# Work Order ID 105211

Item Name: Crosstube Turning DetailL

<b>DART AEROSPACE LTD</b>		<b>Work Order:</b>	105211
<b>Description:</b> Crosstube Assembly (206L High Fwd)		<b>Part Number:</b>	D206-667-143
<b>Inspection Dwg:</b> D206-667-143 Rev: C		<b>Page 1 of 2</b>

DRAWING NO. D206-667-143	TITLE CROSSTUBE ASS'Y (206L HIGH FWD)	REV. C	<b>DART AEROSPACE LTD ENGINEERING ORDER</b>		D.E.O. NO. D206-667-143-C-1	SHEET NO. SHEET 1 OF 1	SCALE NTS
DRAWN <i>q</i>	CHECKED <i>ASS</i>	MFG. APPR. <i>[Signature]</i>	APPROVED <i>[Signature]</i>	DE APPR. <i>[Signature]</i>			
DATE 11.07.15	DATE 11.07.20	DATE 11.07.21	DATE 11/07/21	DATE 11.07.21

REV. C SHEET 2 OF 4

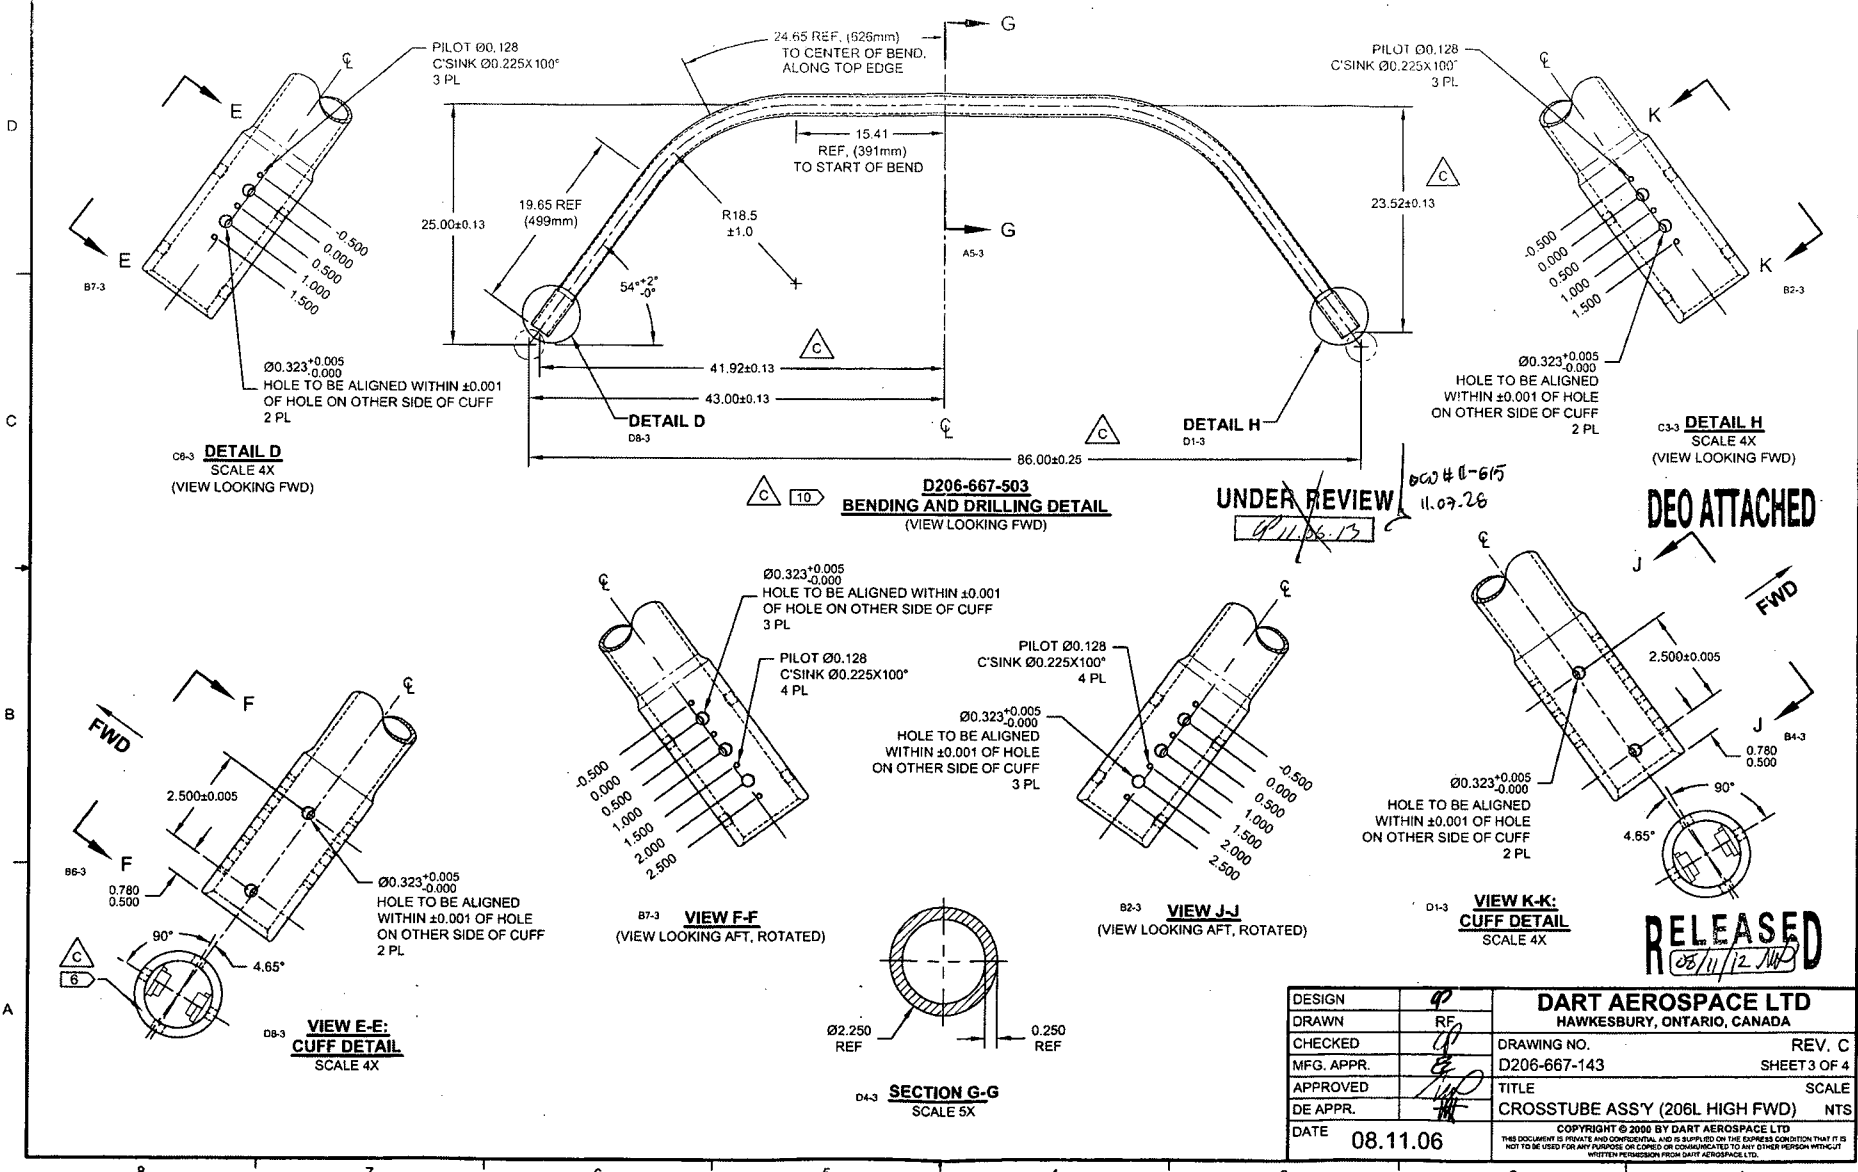
**PURPOSE:**

REPLACE MAGNOBOND WITH PROSEAL.

NOTE 12 & 15, SHEET 1 IS AMENDED AS FOLLOWS:

Item	Qty -143	Part Number	Description
9	A/R	PROSEAL 890 B-2	SEALANT, AMS-S-8802 CLASS B-2

- 12) TO INSTALL D2891-1 SUPPORT: ABRASE MATING SURFACE OF SUPPORT AND CROSSTUBE WITH 180-GRIT SANDPAPER AND REMOVE RESIDUE WITH MEK (OR EQUIVALENT). APPLY A 0.04" TO 0.07" THICK LAYER OF PROSEAL 890 CLASS B-2 (OR AMS-S-8802 CLASS B-2) SEALANT TO MATING SURFACE OF SUPPORT.
- 15) TORQUE CLAMPS 80 TO 100 IN-LB. ENSURE AT LEAST 1.5 THREADS SHOWING IN SAFETY AND THAT NUT HAS NOT BOTTOMED-OUT AFTER TORQUING. **PRIOR TO PACKAGING, RE-CHECK TORQUE ON CLAMPS AFTER PROSEAL 890 SEALANT HAS CURED FOR 72 HOURS.**

**DETAIL P**  
BONDING STRAP INSTALLATION 2 PL

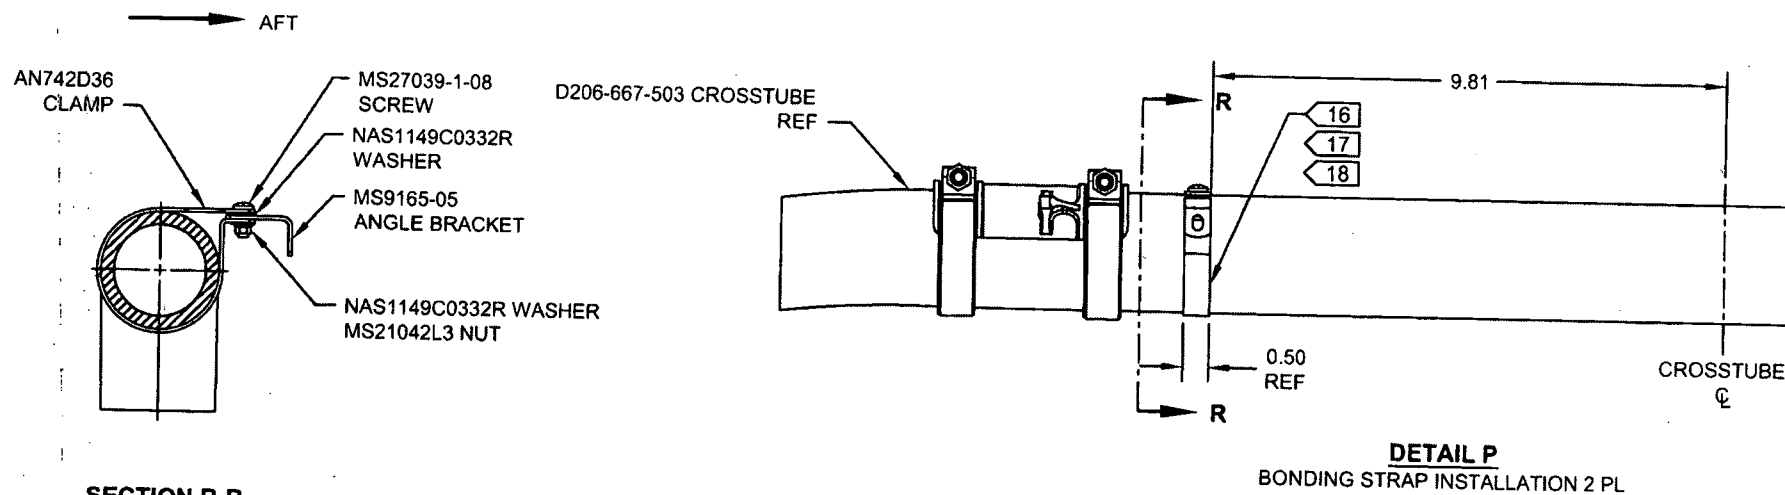
**PURPOSE:**

ADD ELECTRICAL GROUNDING STRAP

ADD

ITEM	QTY -143	PART NUMBER	DESCRIPTION
1	X	D206-667-143	CROSSTUBE ASSEMBLY (206L HIGH FWD)
10	2	AN742D36	CLAMP
11	2	MS9165-05	ANGLE BRACKET
12	2	MS21042L3	NUT (OR MS21042-3)
13	2	MS27039-1-08	SCREW
14	4	NAS1149C0332R	WASHER (OR AN960C10L)

- 16) MASK AREA UNDER CLAMP PRIOR TO PAINTING
- 17) SEAL EDGES WHERE AN742D36 CLAMP MEETS WITH THE CROSSTUBE USING SIKAFLEX-241/-291 OR MIL-S-8802 CLASS B2 OR PROSEAL 890 SEALANT
- 18) PERFORM RESISTANCE CHECK TO ENSURE MAX RESISTANCE IS 10 MILLIOHMS
